ROSA Inc.
Ramapo Organized for Sustainability and a Safe Aquifer
PO Box 712
Pomona, NY 10970

January 7, 2013

RE: Comments regarding Patrick Farm NYS DEC Applications

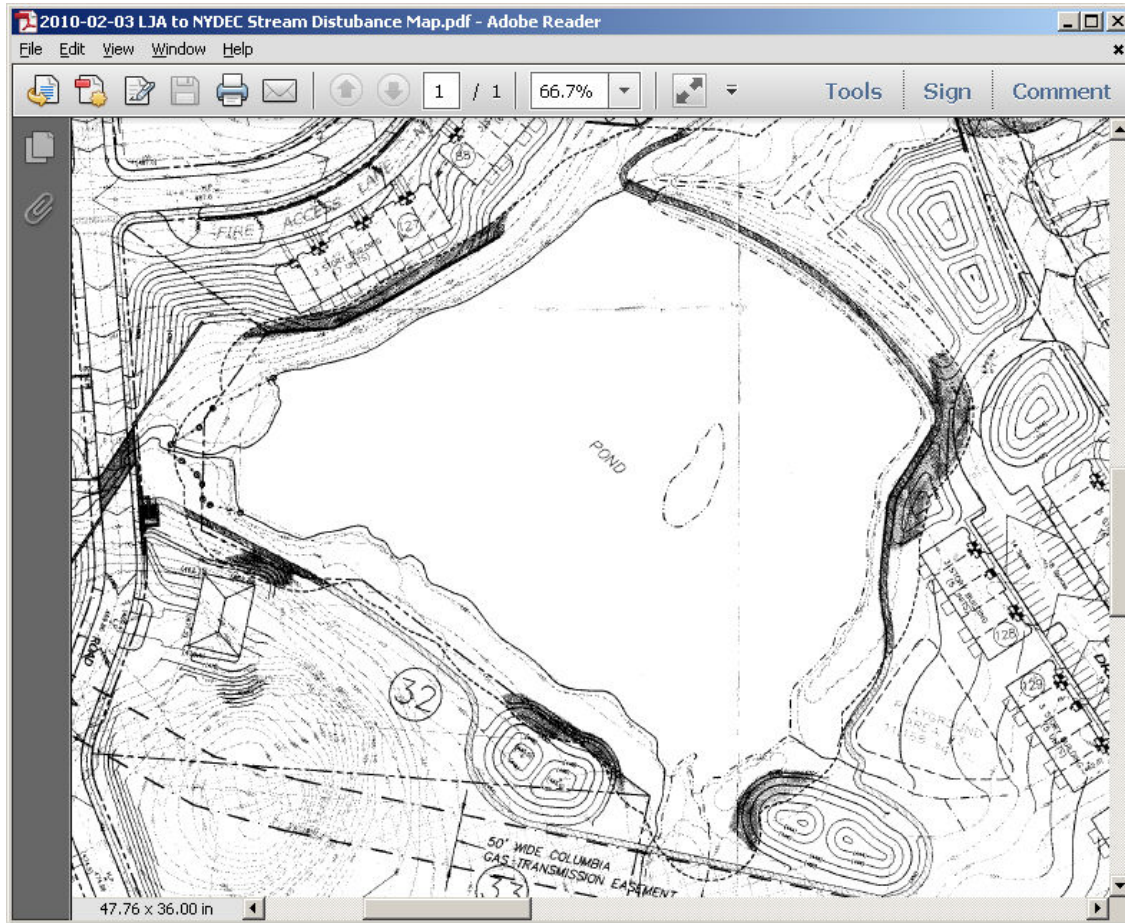
This map was sent to the DEC, and was produced after the applicant made changes to minimize impacts pointed out by the DEC. It still shows, however, eleven areas of potential disturbances – i.e., more than the two currently shown in the application. This map also understates the number disturbances because the wetlands adjacent to the WOUS tributaries to the Pond south and north of the pond are not documented and details of the construction are not complete. Three of the stream crossings are related to WOUS that are not regulated by the DEC but three are related to DEC regulated waters.

The balances of the disturbances shown are related to the in-stream pond and the stream from the pond to the Mahwah River.

Below we have pulled out all the examples of potential streambed disturbances caused by stream crossings or development within wetland 100' boundaries or within 50' of beds and banks. Also note that the applicant did not consistently implement the 50' boundary in this map in the areas where the tributaries join the pond, which are the areas where there are wetlands.

PATRICK FARM SUBDIVISION	TOWN OF RAMAPO
	ROCKLAND COUNTY, NEW YORK
GRADING & DRAINAGE PLAN (PART 2 of 9)	
Job number:	09051
Drawn by:	MAK
Date:	05/24/10
Scale:	1" = 40'
Drawing Number:	14

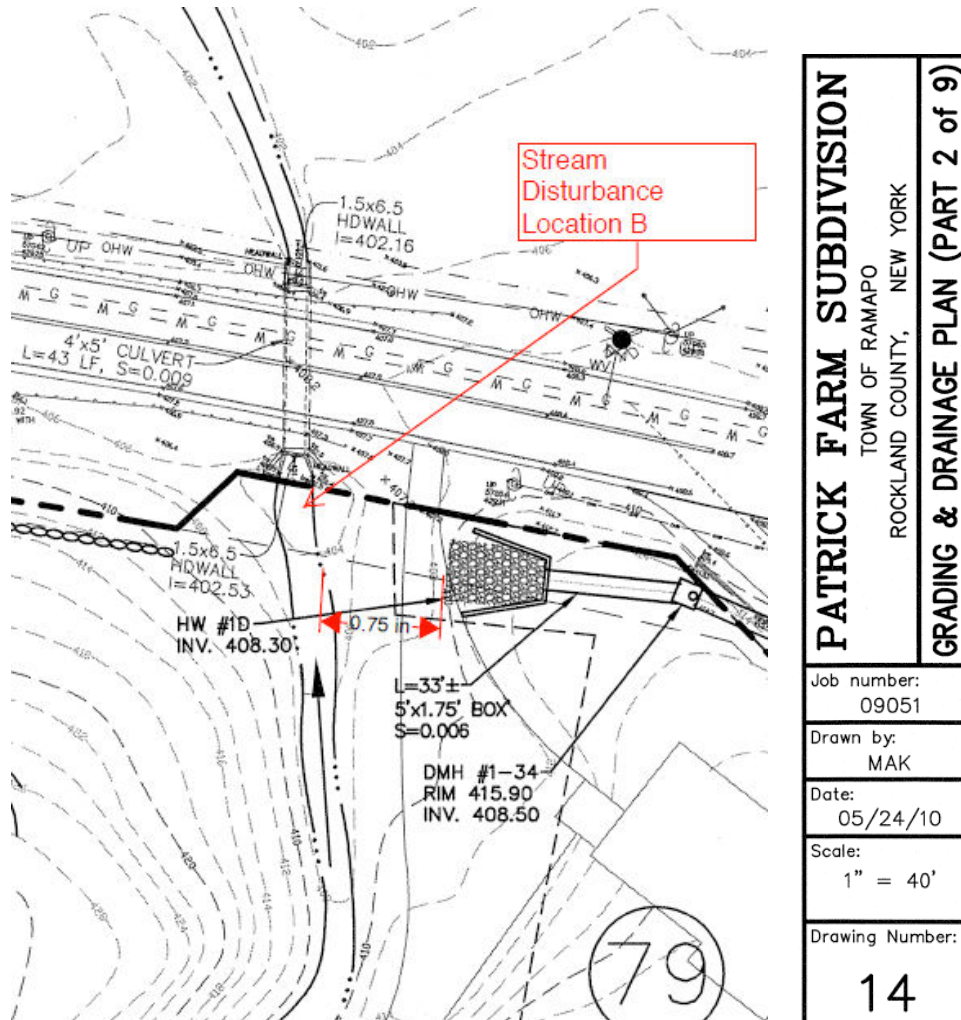
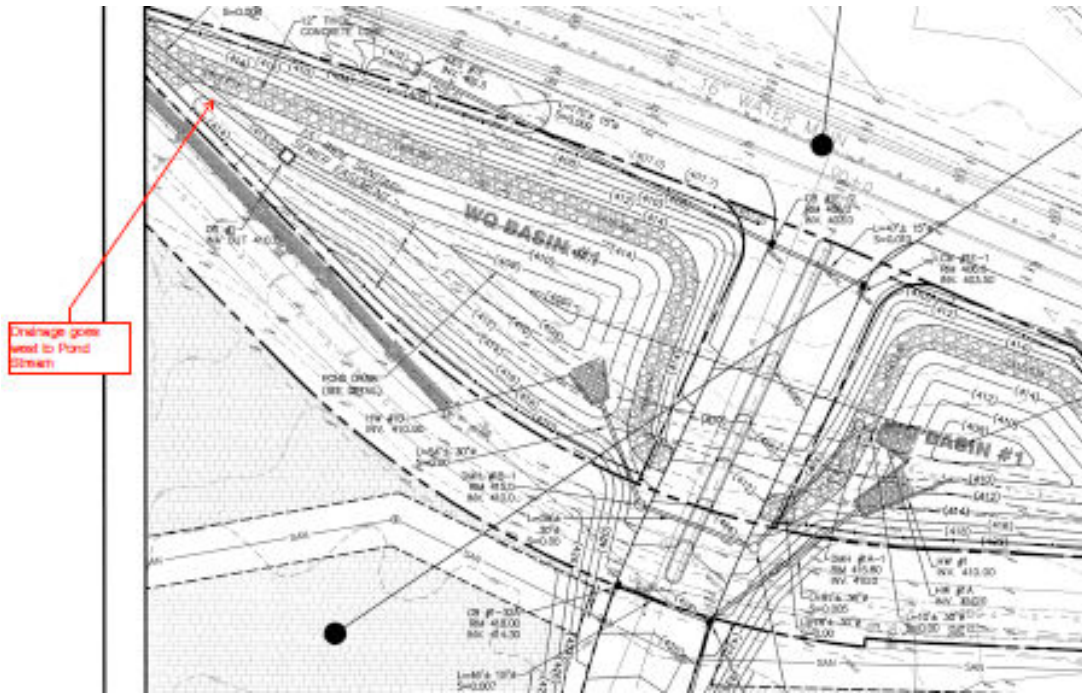
In detailed diagram of Location B in the application why is the limit of the banks on north side of stream so much closer than south side? There is a drainage outflow very nearby. Are those banks confirmed?

On drawing 14 of subdivision the distance from drainage outflow from Basin #1 to stream as shown is ~30' (.75in on 1:40').

The drainage is coming from the large WQ Basin #1 which shown on drawing #15 (see next image).

Culvert #2 Road A Stream Crossing Over ACOE A

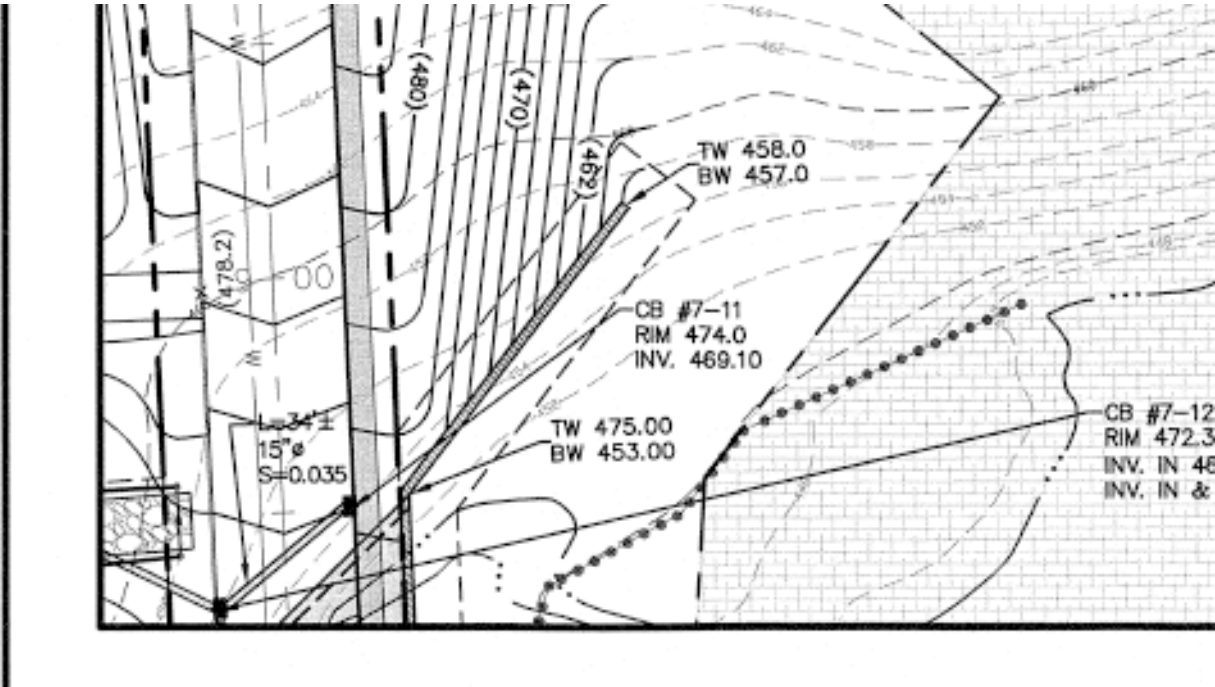
This Road is west of the pond and crosses over the stream connecting the documented ACOE Wetland A to ACOE Wetland B; however along the banks of the streams are small wetland areas that would also be considered ACOE wetlands and should be protected. On the DEIS Figure 3.1-7 below you can see a large amount of fill is planned for this area. Without an ACOE JD, the DEC cannot determine the extent of the disturbance of protected resources.

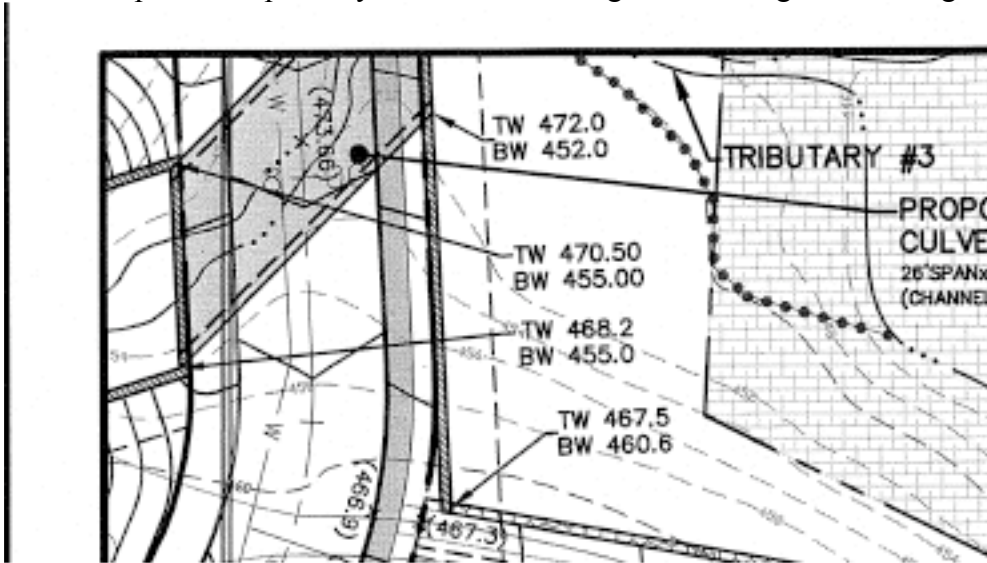
This culvert adjacent to the west corner of the pond is only partially shown without 50' boundary indicators on the Subdivision Plans Drawing #14 Grading and Drainage Part 2 of 9.

The other portion is partially shown on Drawing #18 Grading and Drainage Part 6 of 9.

Culvert #8 Road D Stream Crossing over DEC Class B Stream – Brian Brook

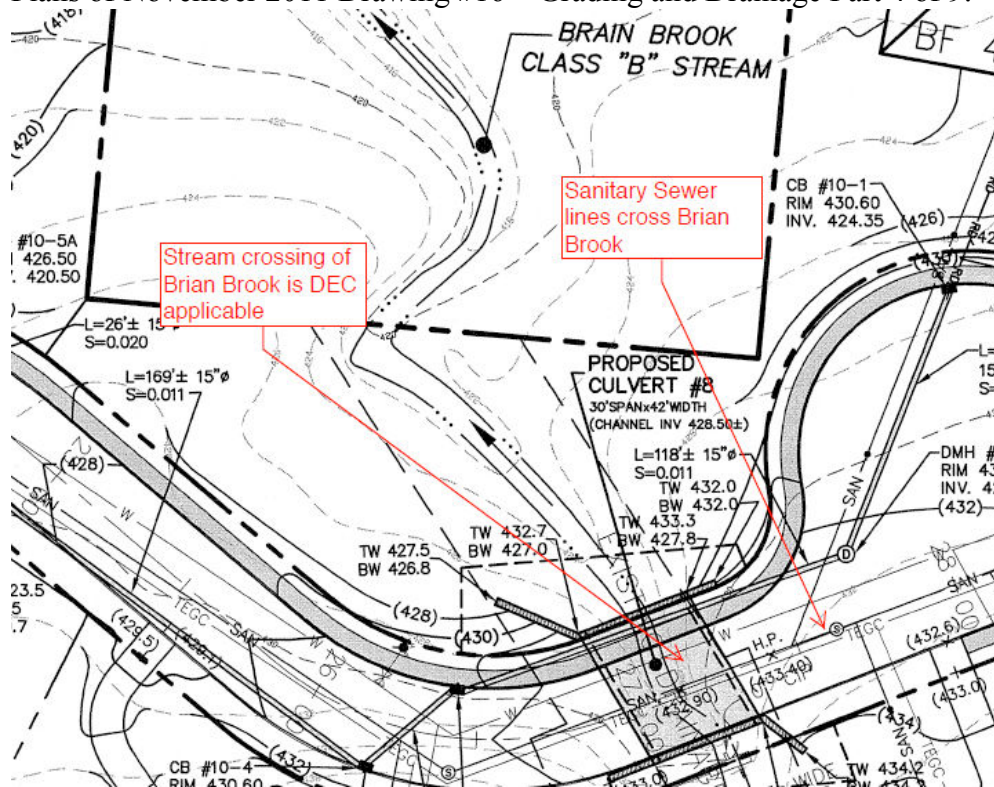
Screen Capture of cut and fill map from DEIS showing planned stream crossing of Brian Brook. Part of subdivision plan. Teal green denotes fill. Lime green denotes cuts. A statement of need should accompany all disturbances. Why do these 5 homes (67, 68, 69, 70 and 71) need to be connected to the subdivision? Why not use a common road onto Rte. 306 instead of crossing the stream?

Even if DEC agrees that this crossing is necessary, there should still be a confirmation of the beds and banks of the stream and a requirement for the developer to confirm the related cut and fill plans and the stream crossing plans. This stream crossing was not indicated in the stream disturbance application. There were construction plans for the stream crossings but not specific to each location.

In addition to the stream crossing, there are sanitary sewer lines crossing the Brian Brook.

This stream crossing is still on the final subdivision plans along with sewer lines also crossing the Brian Brook and should be part of the application. This was taken from the Final Subdivision Plans of November 2011 Drawing #16 – Grading and Drainage Part 4 of 9.

Culvert #3 for WOUS tributary #3 to ACOE A

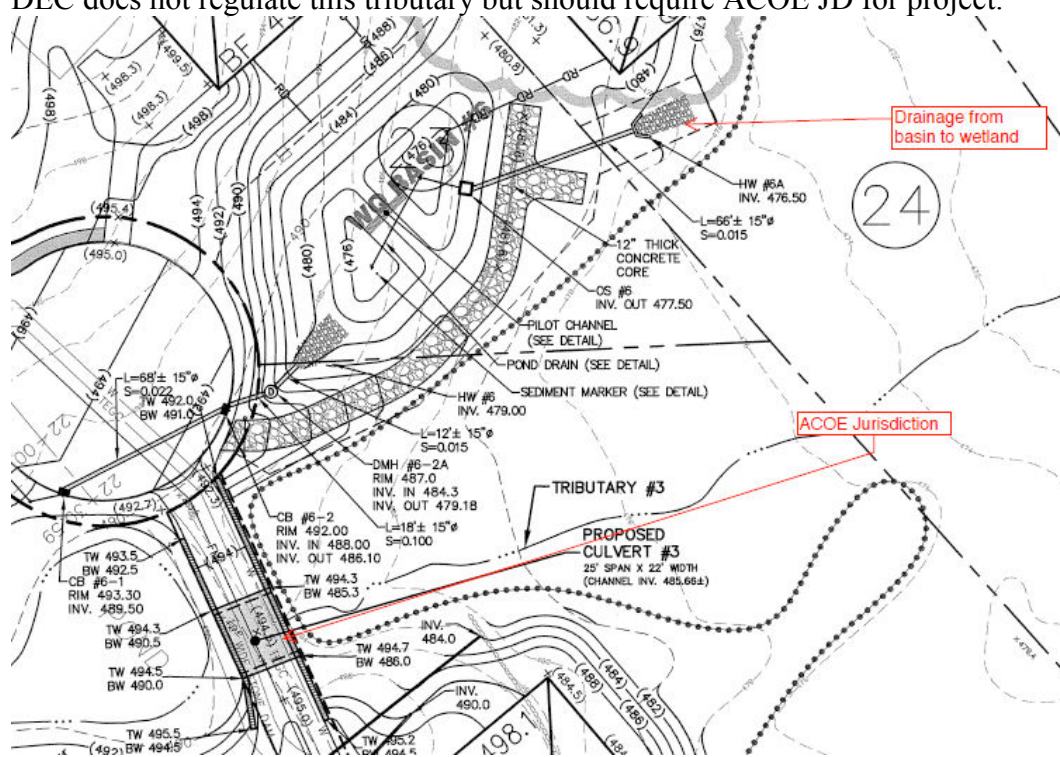
DEC does not regulate this tributary but should require ACOE JD for project.

Culvert #4 for WOUS tributary #4 to ACOE A

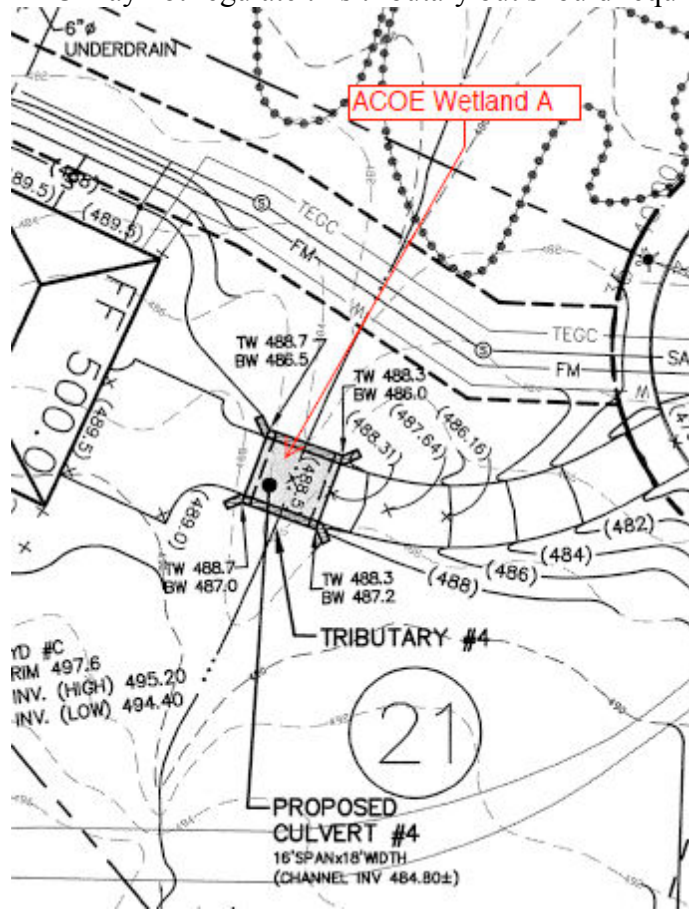
DEC may not regulate this tributary but should require ACOE JD for project.

Culvert #5 for WOUS Tributary #2 to Pond

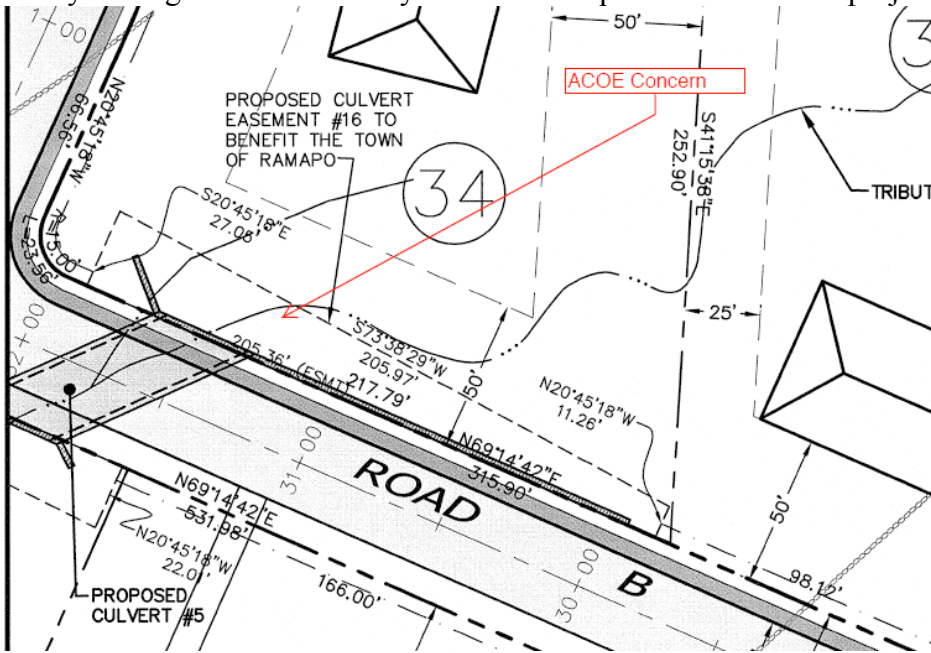
DEC may not regulate this tributary but should require ACOE JD for project.

Homes Sandwiched between Columbia Gas Easement and DEC Wetland

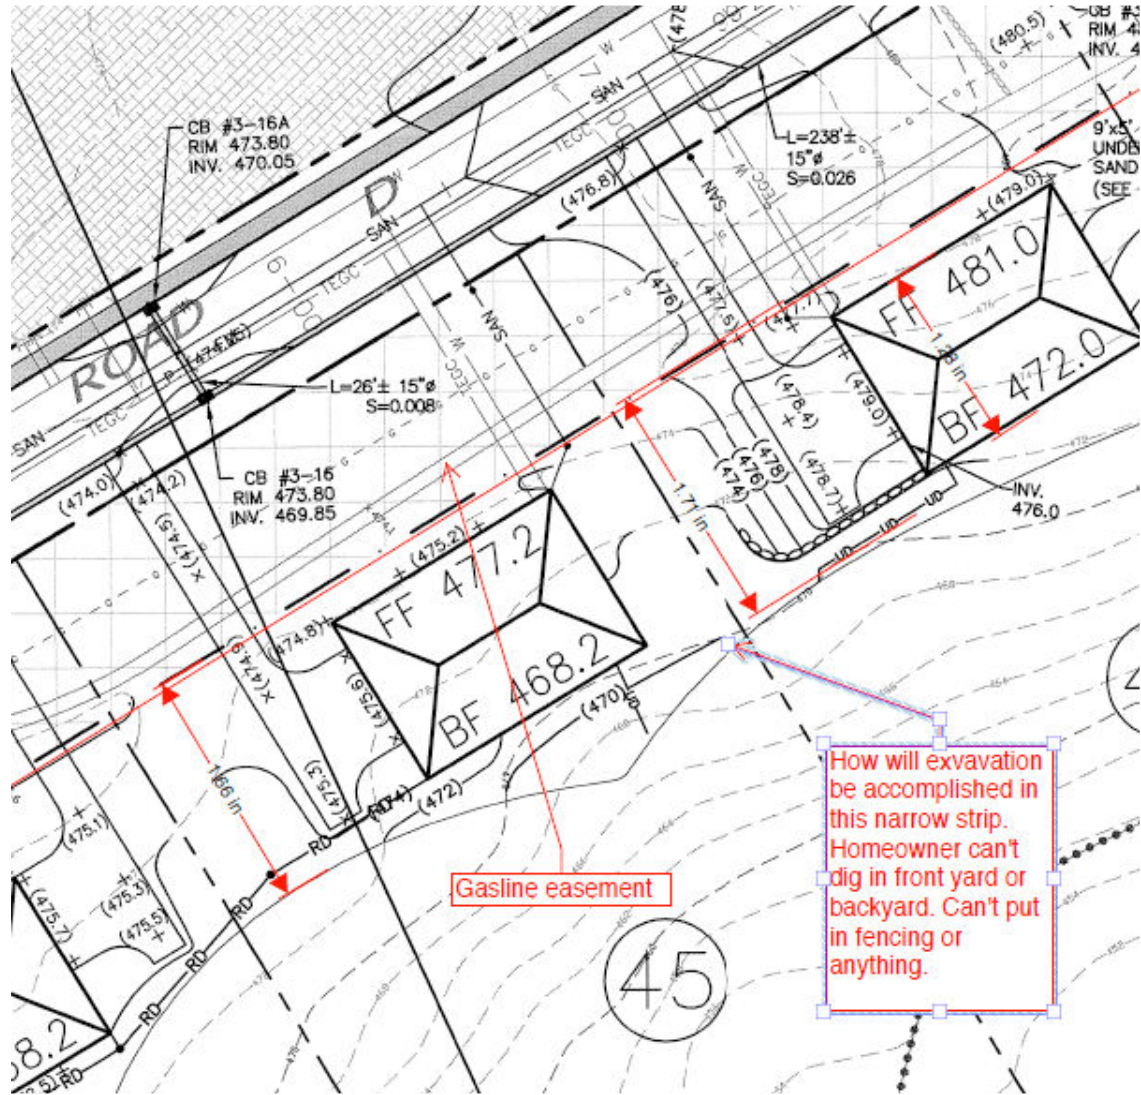
Homes 44, 45, 46 and 47 are sandwiched between a high-pressure gas pipeline and DEC wetland. For lots 45 and 46 the distance between the two easements is 70-80'. All excavation for homes 50' deep need to take place within this narrow strip leading to possible infringements that should be noted and considered.

Water Quality Basin #3

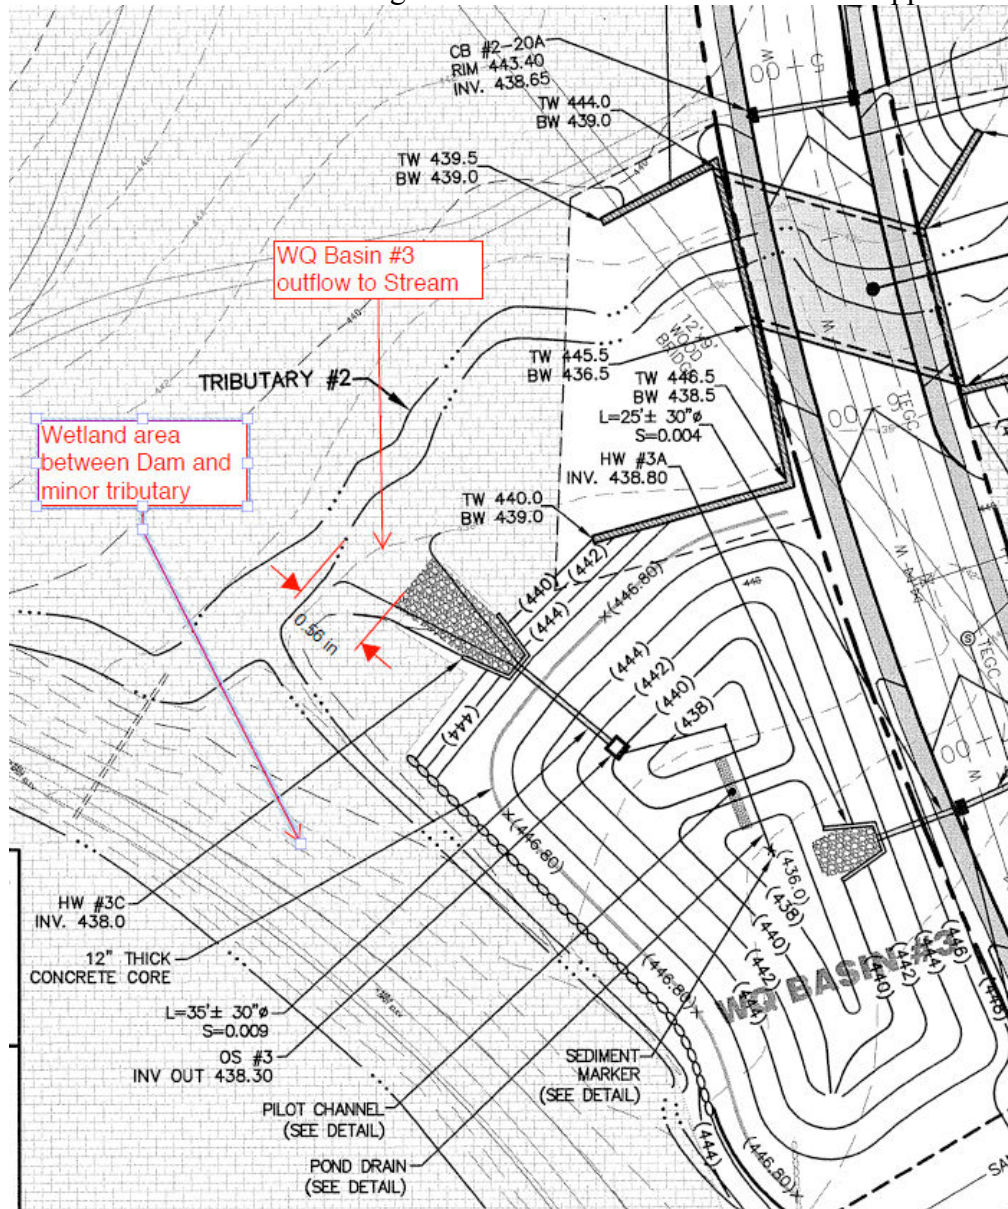
Shown on subdivision drawing #14 drains to class B Stream within approximately 25' of stream.
